MFD NON-COMPLIANCE REPORT # 29464-2

PART NAME: **LENS MOUNT BRACKET**
PF/SA NO.: **PF-391-523-74 R0**
WORK ORDER NO.: **29464-2**
VENDOR: **MFD**

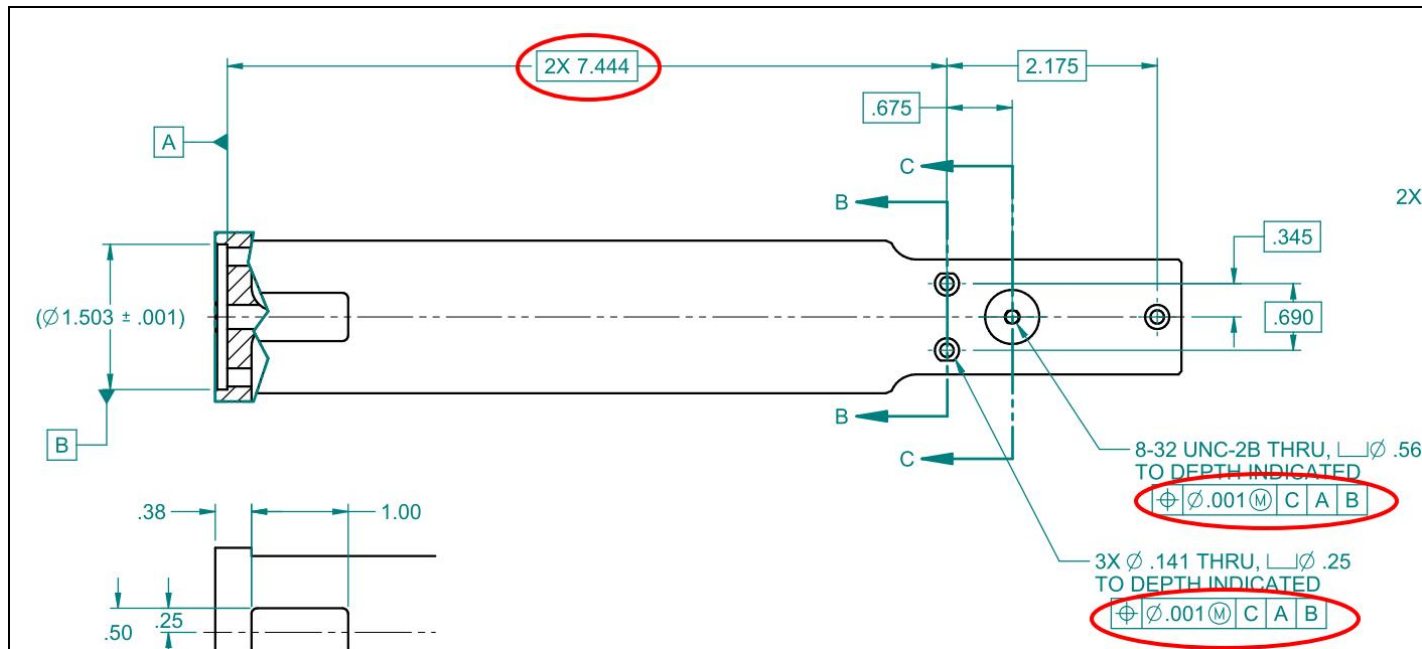
1. Basic Distance 2X 7.444 measures 7.319 (-0.125"), all holes were machined off the end and not Datum -A- therefore all positions are out of tolerance.
